DESIGN/DEVELOPMENT REVIEW COMMISSION

Evaluation Sheet

ADDRESS: 1043 Huger Street

NATURE OF REQUEST: Request for Certificate of Design Approval for new construction

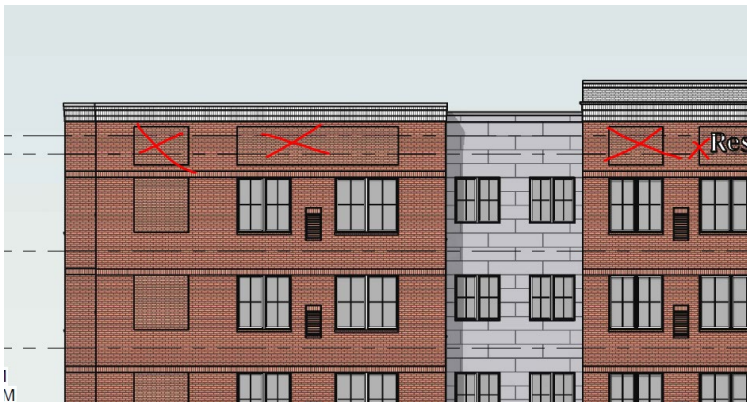
(staff comments) The building has defined bays, as noted earlier, and is very well articulated at the street level with brick detailing, storefront panels with transoms and paneling. The canopy is a nice feature for shade and articulation. Altogether, there is a lot going on and the first floor façade reads a bit busy. A recommendation might be to eliminate the composite storefront paneling so that the storefront windows and transoms sit cleanly within the punched brick openings and between the nicely detailed columns.

Residence Inn - Vista
Huger Street, Columbia, S.C.

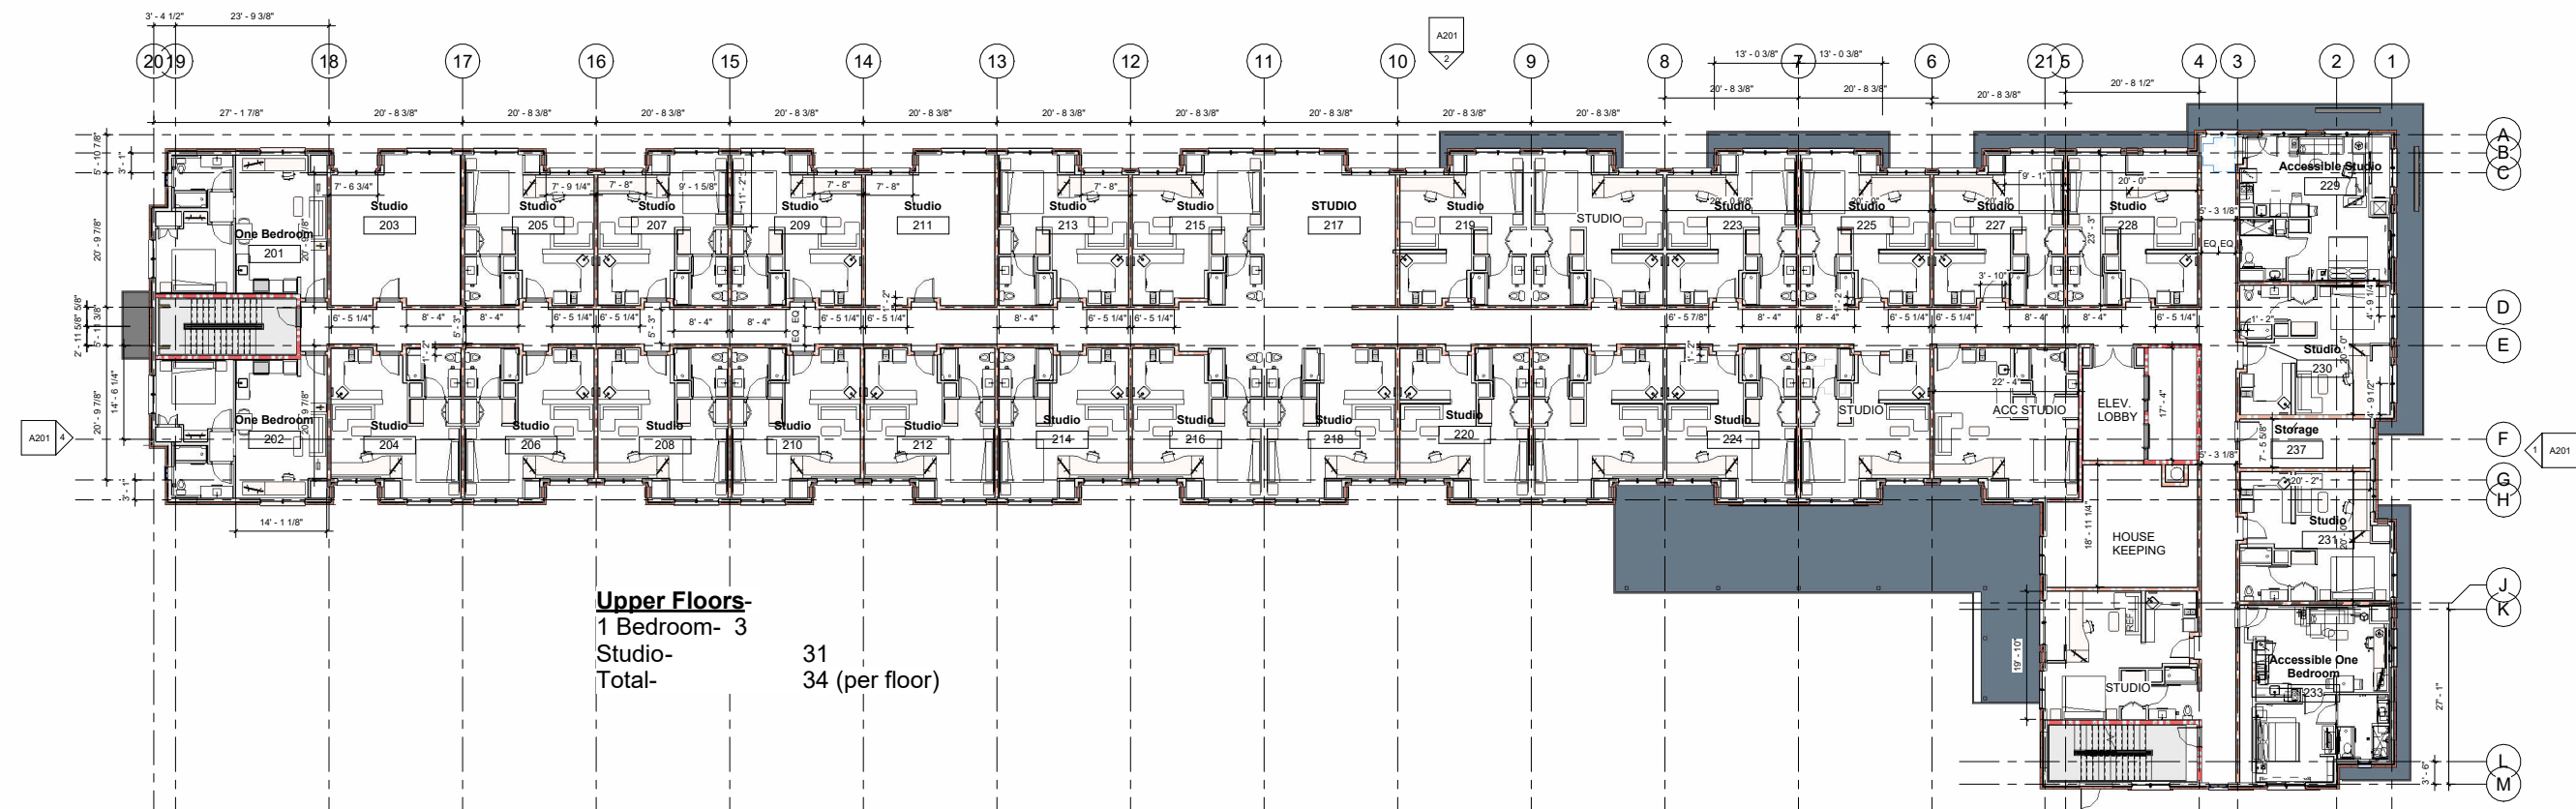
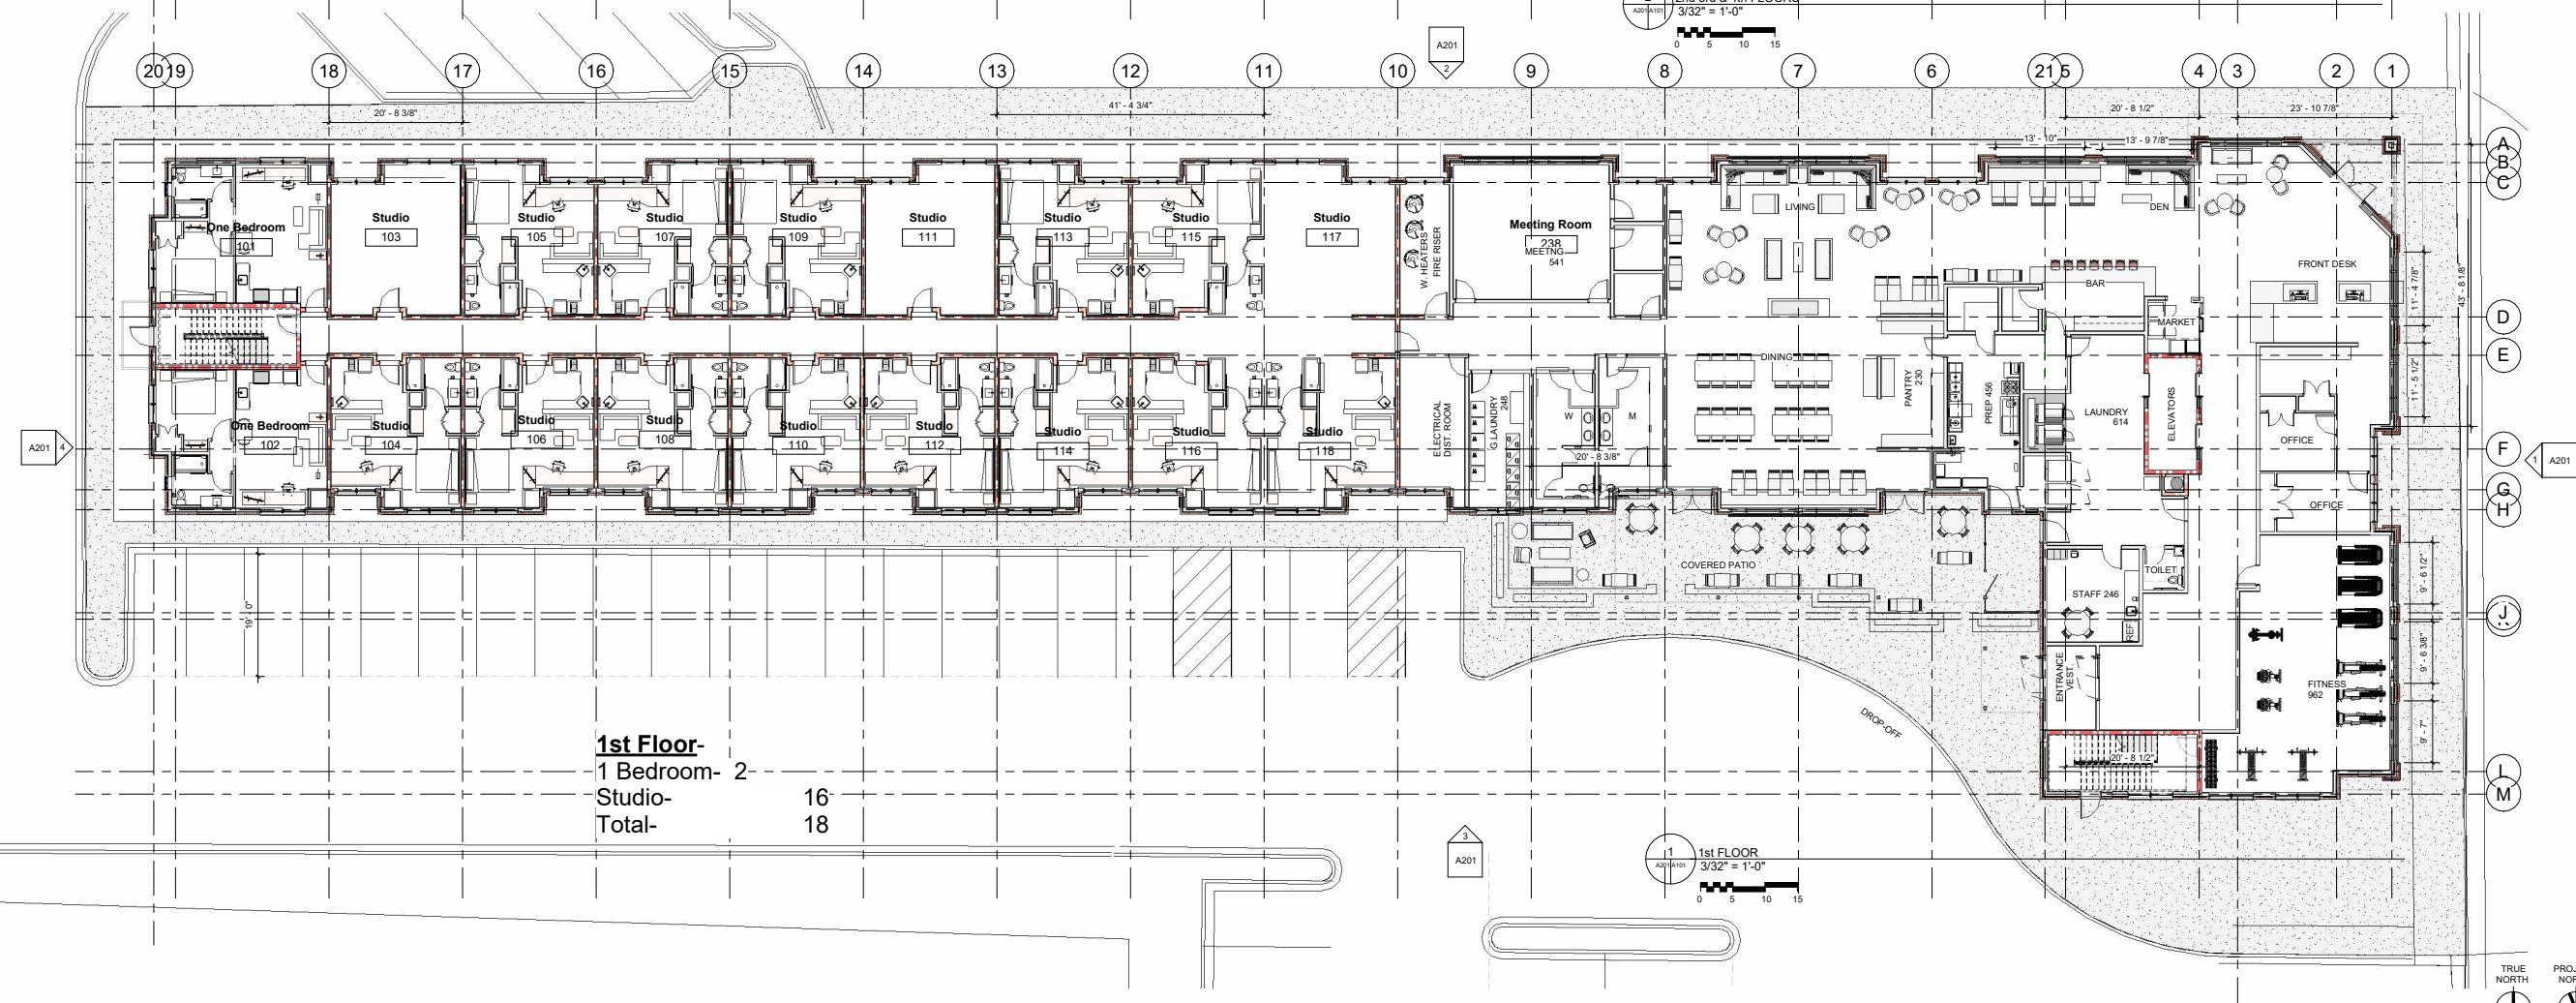
(staff comments) The building is oriented toward both street frontages with a chamfered corner entrance into the main lobby. While there is an entrance to the hotel lobby from the rear parking lot, the floorplan accommodates both street-facing and parking lot-facing entrances into the main lobby space.

(staff comments, Sept.) The building entrance to the lobby has been provided at the street corner, which is important per these guidelines, and also required by the zoning which calls for specific street frontages in Innovista to be "ground floor activity zones." This corner is included in that requirement, and a hotel lobby does qualify as an active ground floor use.

Residence Inn - Vista
Huger Street, Columbia, S.C.
ELEVATIONS

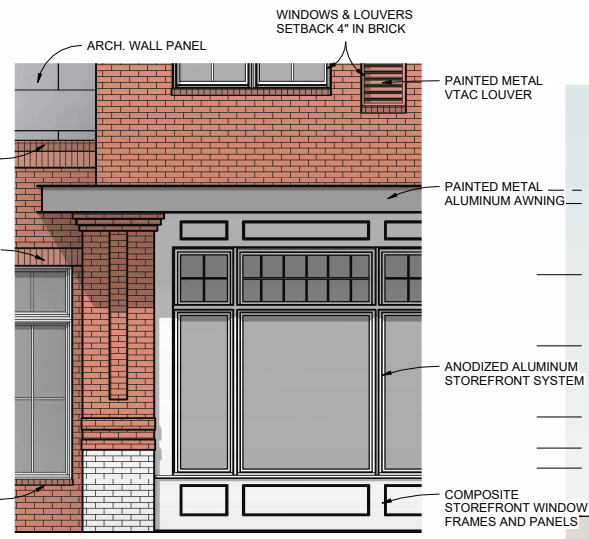
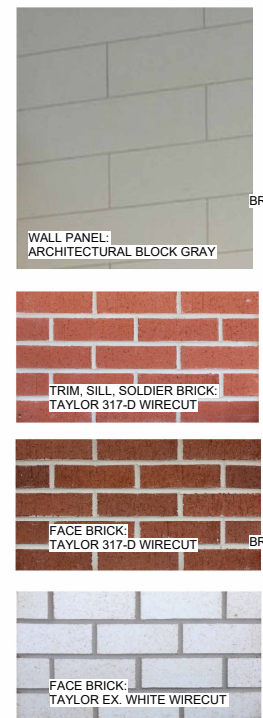
(staff comments) The percentages have been included, as follows:

Huger Street upper floors: 21.2%
Huger Street ground floor: 72.6%

Senate Street upper floors: 28%
Senate Street ground floor: 54.3%

The lower than recommended percentages is in part due to the large amount of wall above the fourth floor windows in addition to the brick recessed areas where the building's interior program is not compatible with windows. While the window openings do not appear to be significantly out of scale with the façade, they could be slightly larger to get a bit closer to the recommended percentages.

Blank wall areas contributing to the lower than recommended proportion of openings.

(staff comments) The roof is flat, consistent with the buildings in the area. The parapet and cornice provide nice detailing with brick corbelling, which would stand on its own without a change in color to the white brick. The recessed brick panels above the upper floor windows appear extraneous, and staff recommends the elimination of these where they are not in place of windows.

The red field brick and lighter red accent brick provide subtle detailing consistent with the traditional style of the building, The white brick at the base and on the parapet helps to tie in with the lighter paneling color, however the white brick at the column bases somewhat detracts from the visual base of the building. As well, having white brick along the sidewalk on a busy urban thoroughfare may prove to be a cleaning/maintenance issue.

- That the site plan improvements as specified in encroachment ordinance, 2022-032 be implemented by developer;
- Eliminating the articulated panels in the brick band above the upper floor windows;
- Eliminating the composite storefront panels and the white brick at the base of the columns to provide a continuous red brick base;
- Streamlining the cornice design as noted;
- Increasing the percentage of upper-story window openings by at least 5%;
- Providing a minimum window depth of 4” for the brick encased windows, and
- all other details to be deferred to staff.
